UNITED STATES PATENT AND TRADEMARK OFFICE

10/689,472

Office Action Summary

DETAILED ACTION

FIG. 5

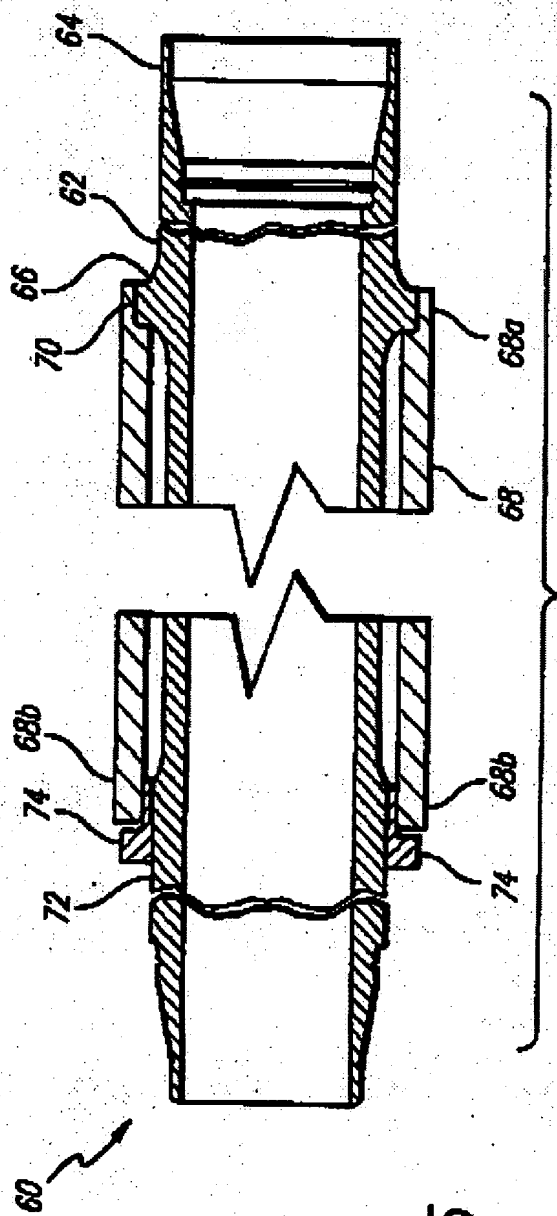
3. Claims 1 through 3, 10, 11, 34 through 36, 43 and 44 are rejected under 35 U.S.C. 102(b) as being anticipated by Halkyard (U.S. Patent No. 5,683,205 A).

Halkyard '205, as seen in Figure 5, shows a centralizer system (60) comprising:
with regard to claims 1 and 34,

a metallic pipe (62; as admitted by cross section see MPEP 608.02) comprising a pipe outer diameter less than the inner diameter of a receptacle (68) so as to be insertable into the receptacle and relatively moveable within the receptacle (col. 3, lines 28 through 49);

a metallic upset portion (72) formed on said metallic pipe having an upset outer diameter greater than said pipe outer diameter, said pipe and said upset portion being a monolithic structure; and

a metallic centralizer (74; *metallic* as admitted by cross section, see MPEP) in gripping engagement with said upset portion on said metallic pipe whereby said centralizer and said upset are prevented from any relative movement, said centralizer having an outer diameter less than said receptacle inner diameter for insertion into said receptacle;

further comprising an upset transition zone on at least one side of said upset portion, said upset transition zone having an outer diameter equal to said upset portion on one end of said upset transition zone such that said outer diameter of said upset transition zone decreases with distance axially away from said upset portion;

wherein said centralizer is in gripping engagement with at least a portion of the transition zone (i.e., the end of the transition zone);

wherein said centralizer has an outer surface with a curvature portion for contact with said receptacle; and

wherein said centralizer has a substantially cylindrical outer surface portion for contact with said receptacle.

5. Claim 9 is rejected under 35 U.S.C. 103(a) as being unpatentable over Halkyard (U.S. Patent No. 5,683,205 A).

Halkyard '205, as seen in Figure 5, fails to teach :
an insulative coating on an outer surface of the centralizer.
